SEWAGE DISPOSAL SYSTEM

A. REPAIR

HOWARD COUNTY
BUREAU OF ENVIRONMENTAL HEALTH
461-9933

ADDRESS 6048 Meadow Ridge Road

INDICATE NORTH - NAME ADJOINING ROADWAY AS BASE LINE
Meadow Ridge Road

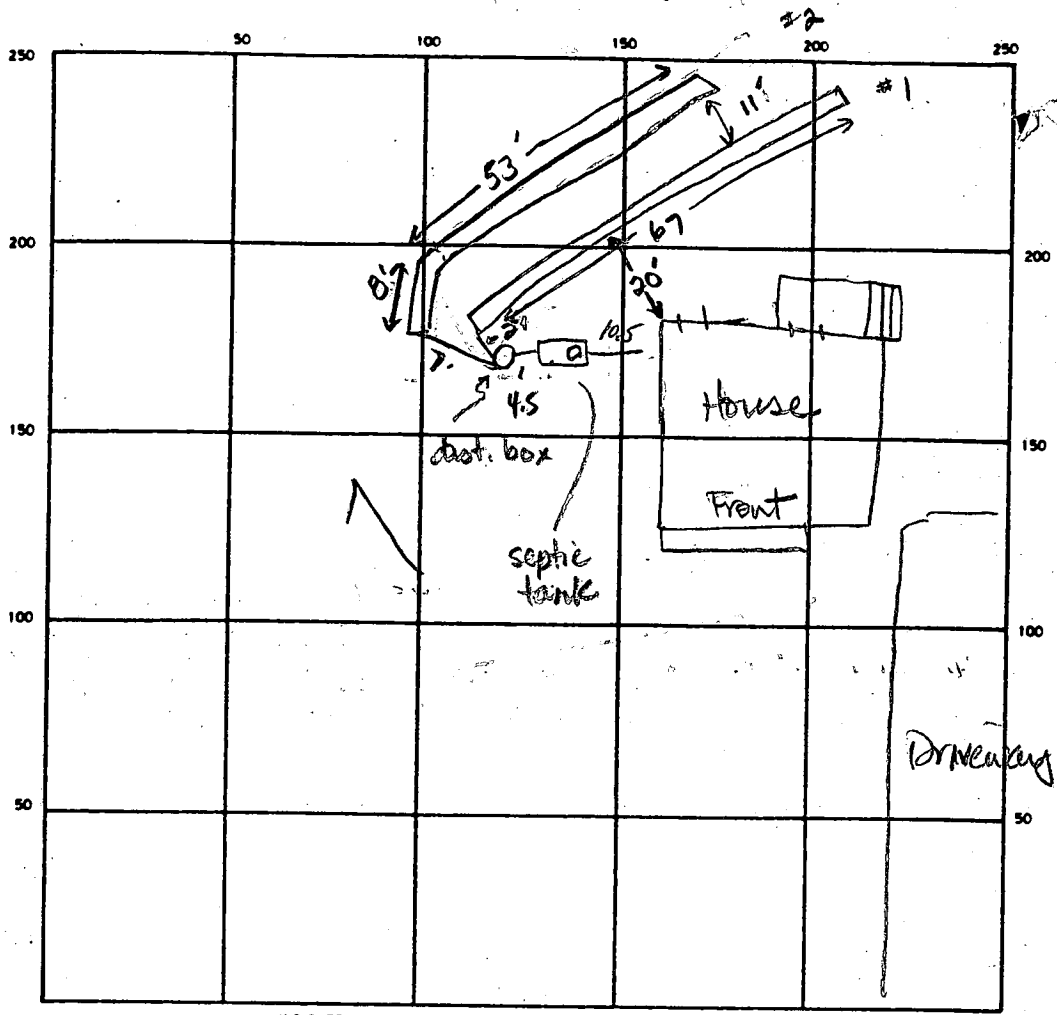
REMARKS 10-27-88 Must change schedule 35 pipe from house to tank to schedule 40 or better. Trench width is 3 ft or wider due to cave-in. OK to shorten length some. Must keep fall from house 1/4 in/ft or less. OK to cover trench #1. JEN 10-27-88 OK to cover trench #2 and other work. Need house connection. JEN

① ②
SOIL PROFILE

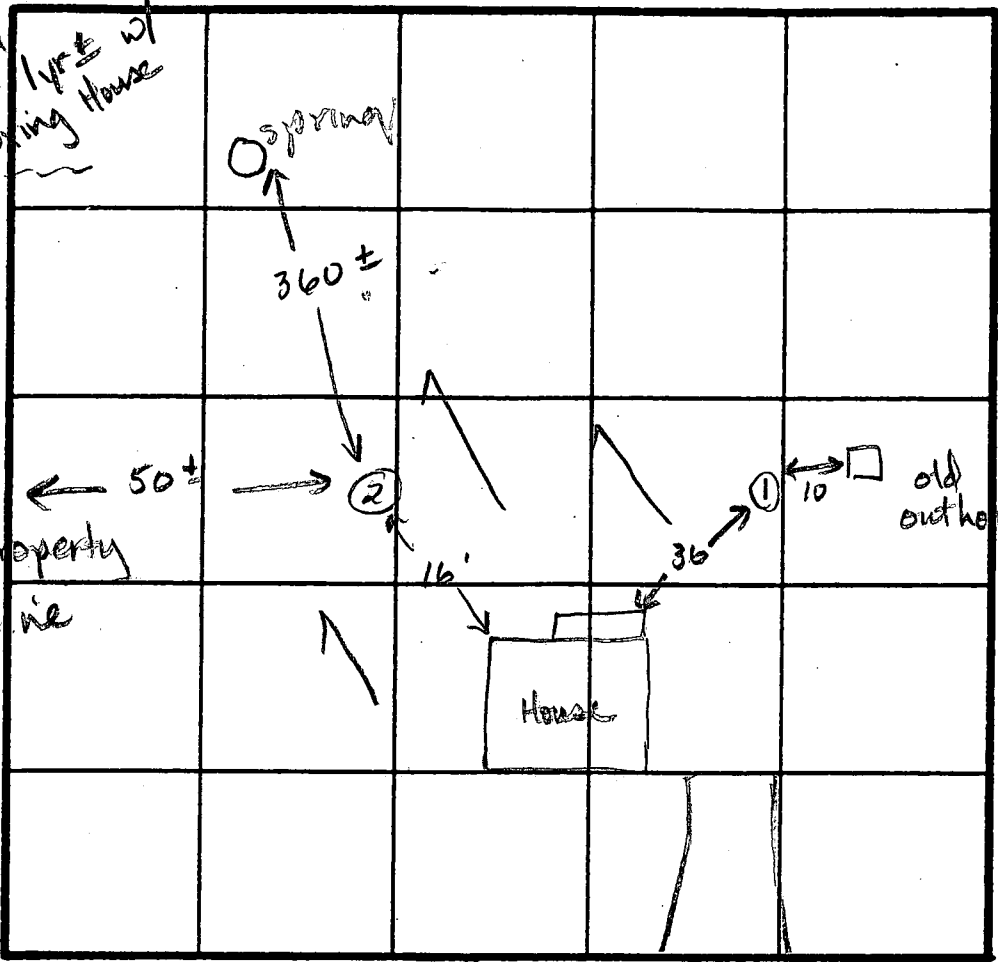
REASONS FOR REJECTION OR HOLDING 10-26-88 Perced area ok for 4 ft stone w/ inlet at 20ft, Bottom at 60 ft. To be connected to public water
JEN,

REMARKS Uniform and sa slm. House has a spring but to be connected to public water soon
